CHANGE ORDER NO.: 4

Owner:	Town of Bristol	Owner's Project No.:	WW22532001
Engineer:	Commonwealth Engineers, Inc.	Engineer's Project No.:	S22145
		Contractor's Project	
Contractor:	Crosby Construction	No.:	24105-01
Project:	WWTP Improvement Project		
Contract Name:	WWTP Improvement Project

Description: Installation of a new manhole at Lift Station #8 and the NIPSCO-requested adjustment of the transformer. Location onsite.

SUBJECT: Wastewater Treatment Plant Improvements
Work Item Breakdown for Change Order No. 4

EX. LIFT STATION NO. 8
SITE IMPROVEMENTS PLAN

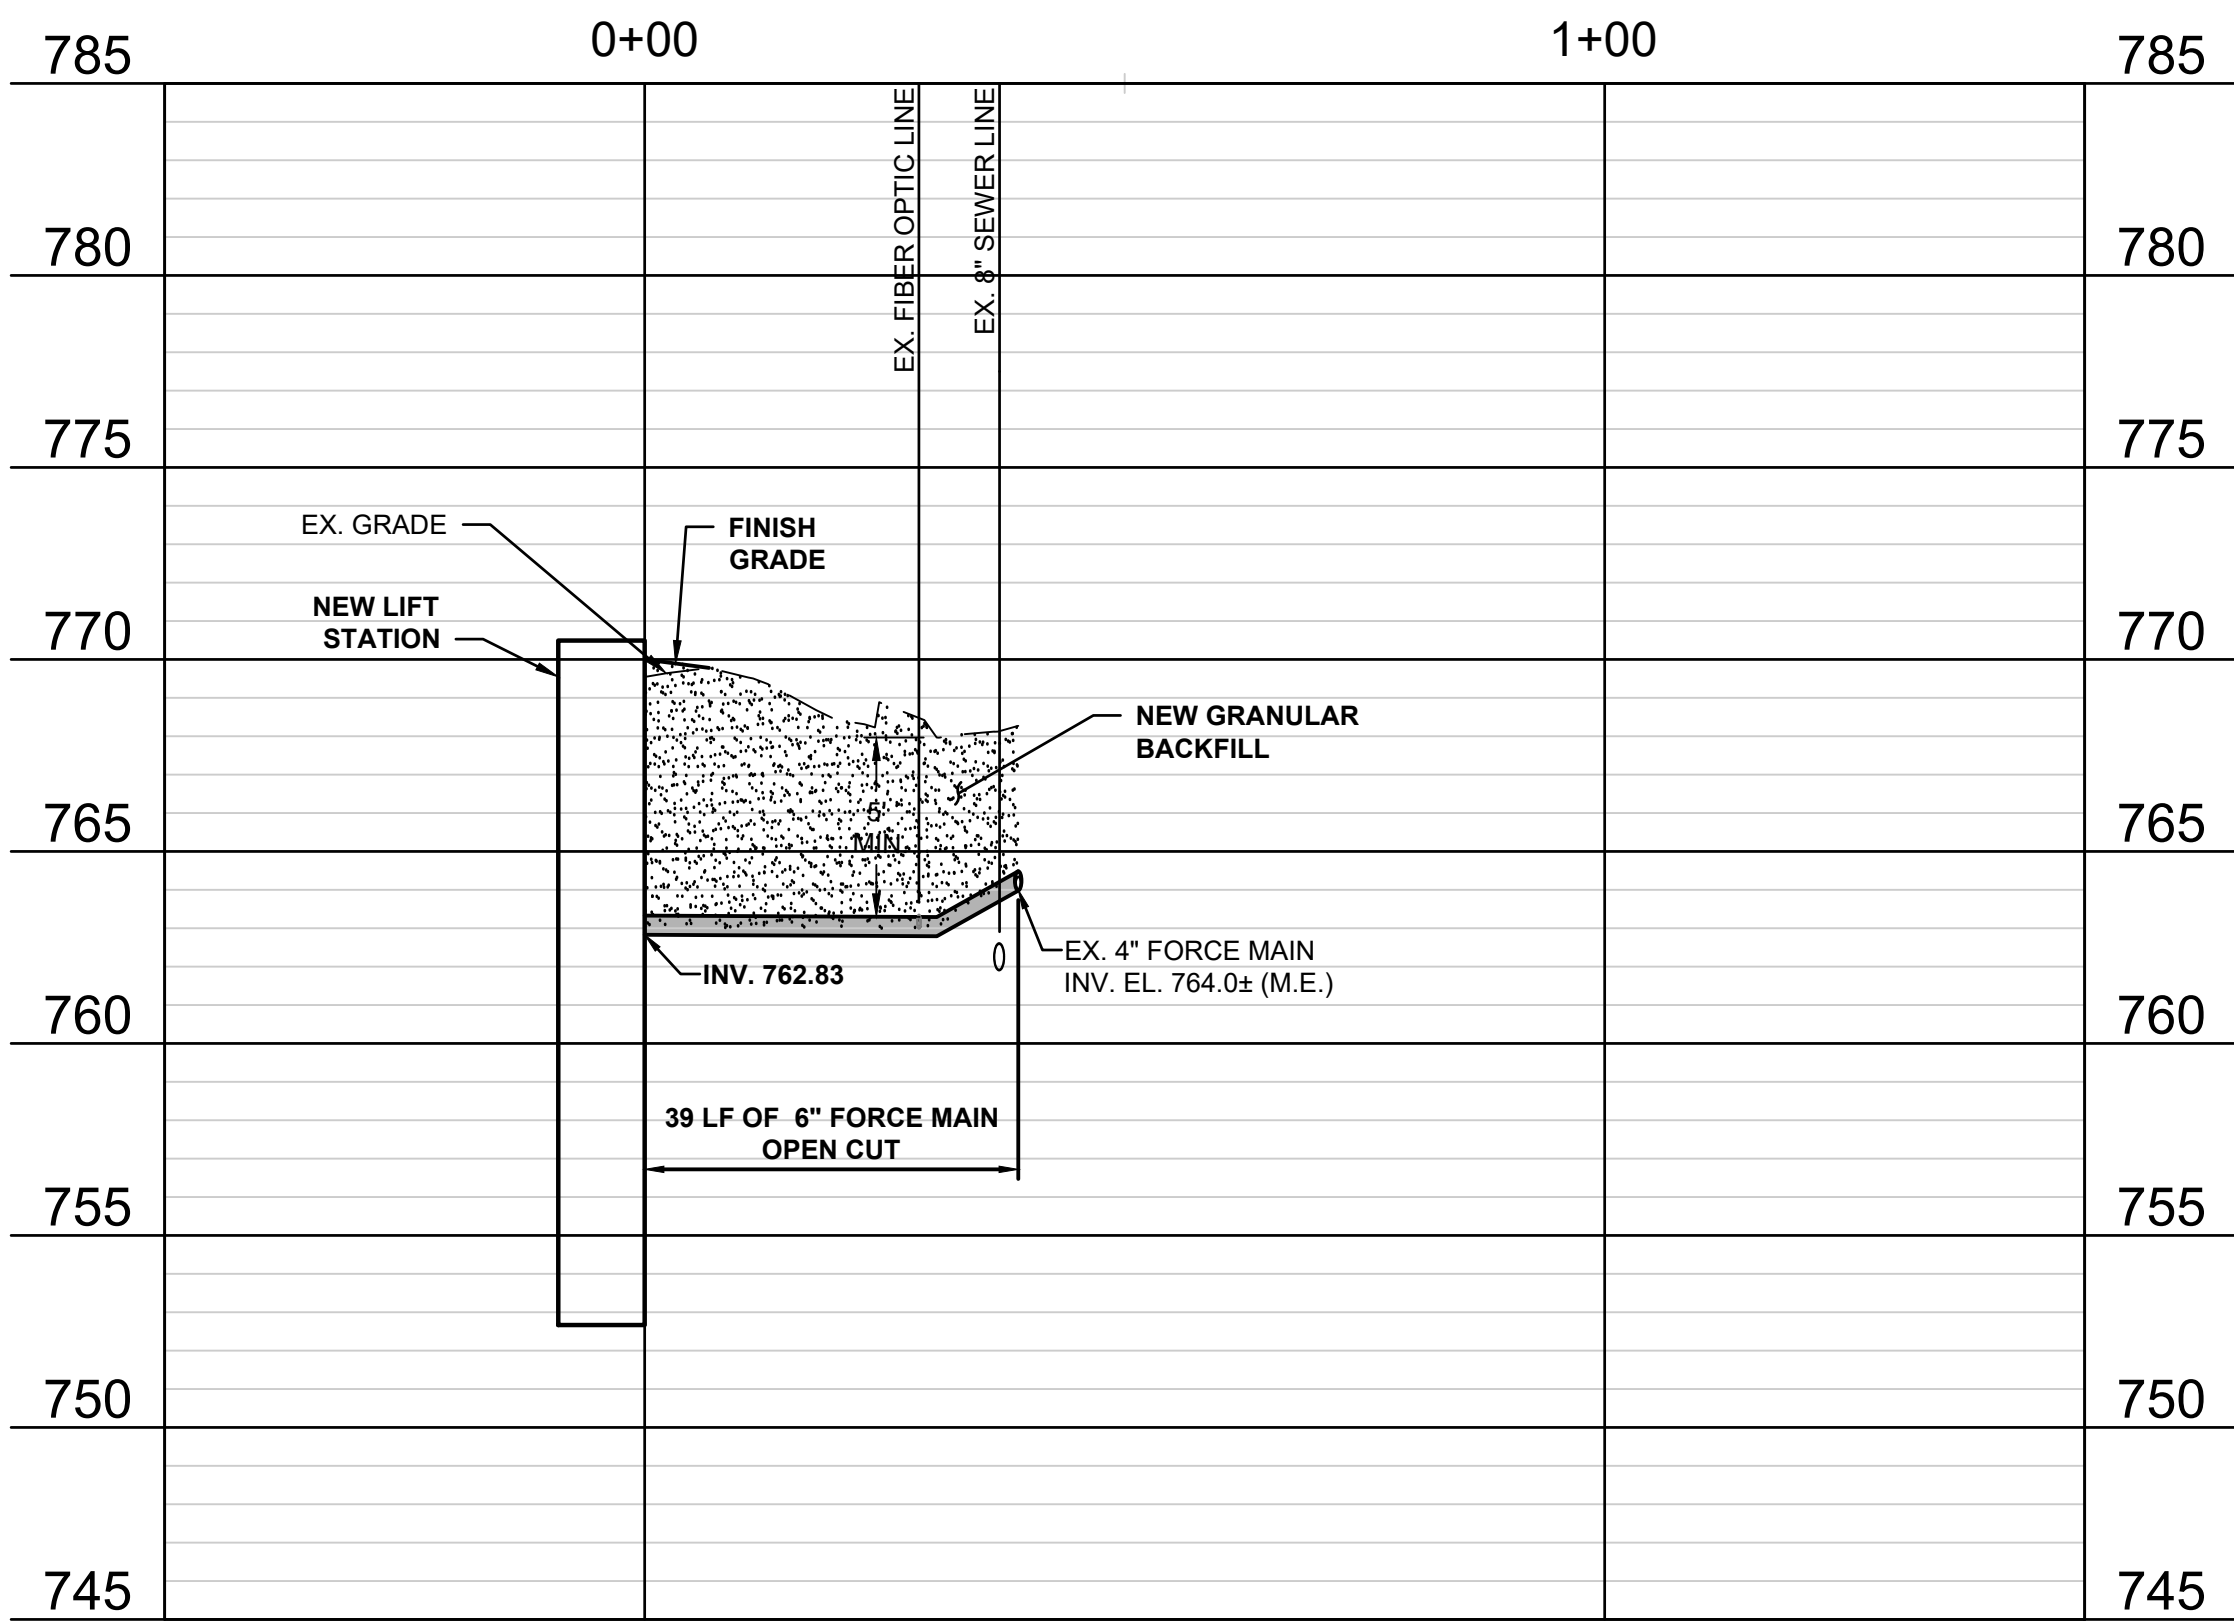
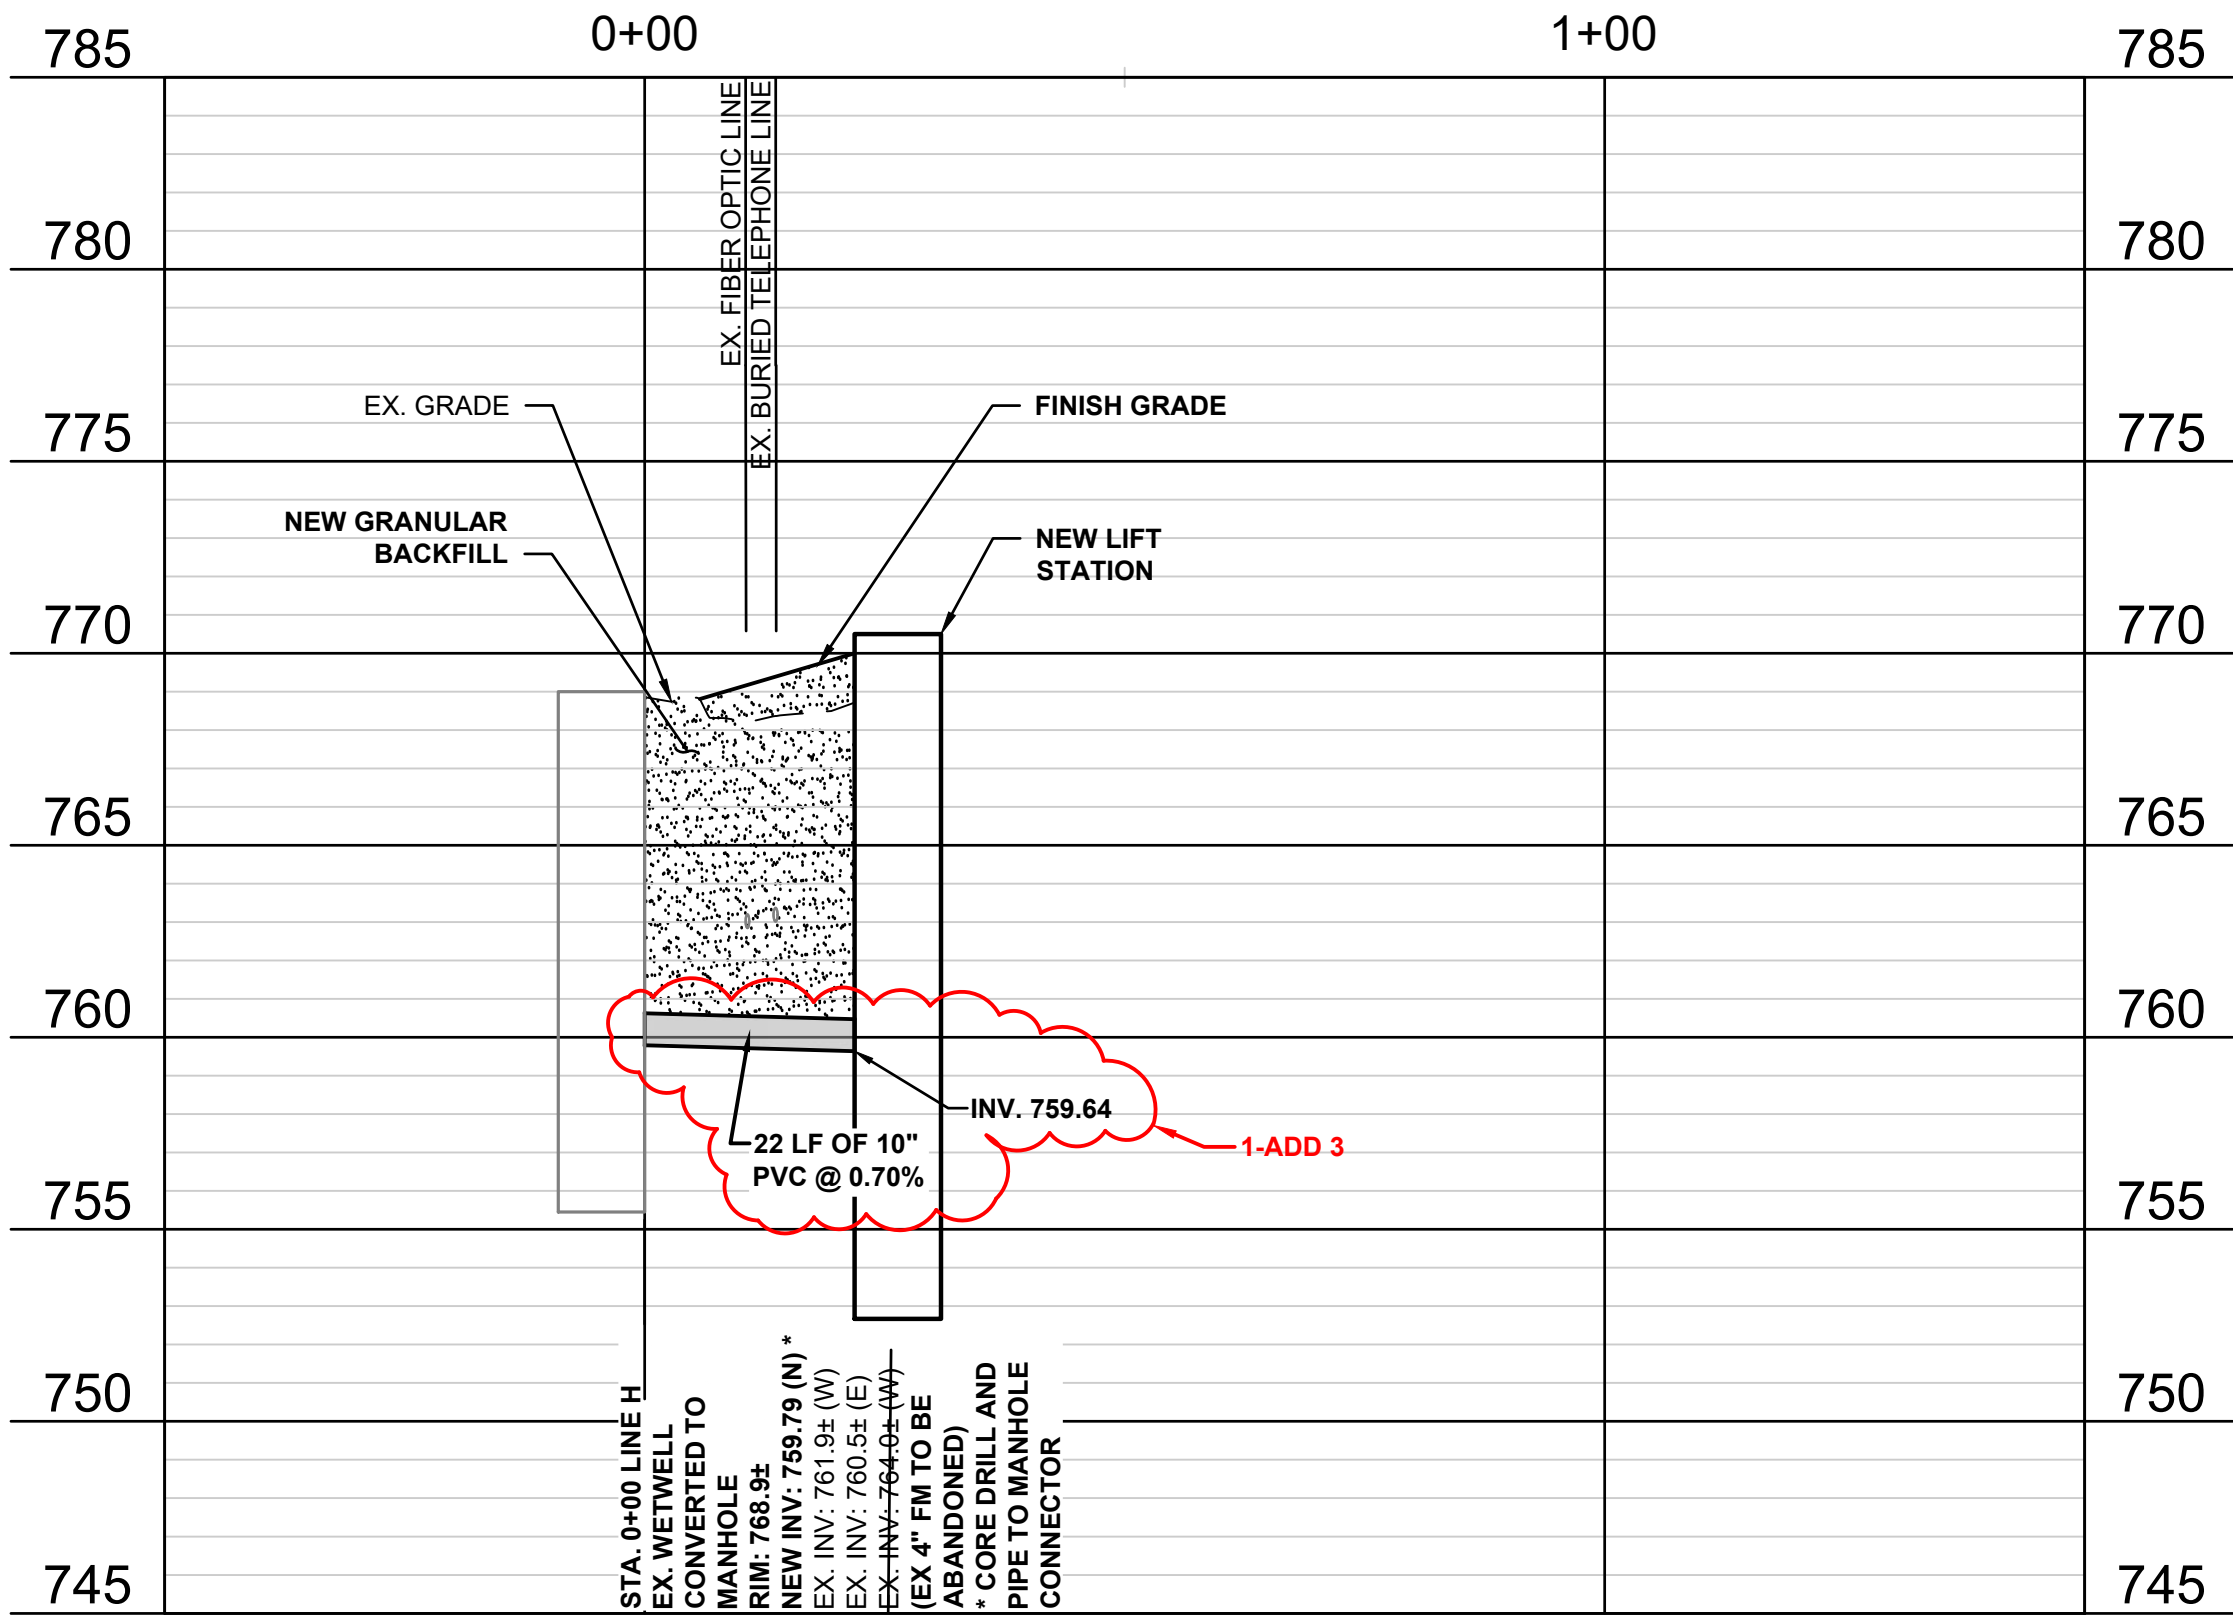
Contractor submitted doghouse MH submittal; comments in last page of attached pdf. Revise and resubmit. Contractor to clarify what measured depth is of existing line from east (is submitted here 0.65' lower than old As Builts suggest). As submitted, the new invert to the north does not provide enough drop to maintain planned invert into new LS 8 (planned for 759.64). If invert out must be 759.62 as submitted, provide adjusted invert at new LS.

ALM REVISIONS 4/28/25
RFI-35

CONTRACTOR TO ADJUST
PROFILE BASED ON NOTES
ON PLAN VIEW AS DIRECTED -
ALM RFI-35
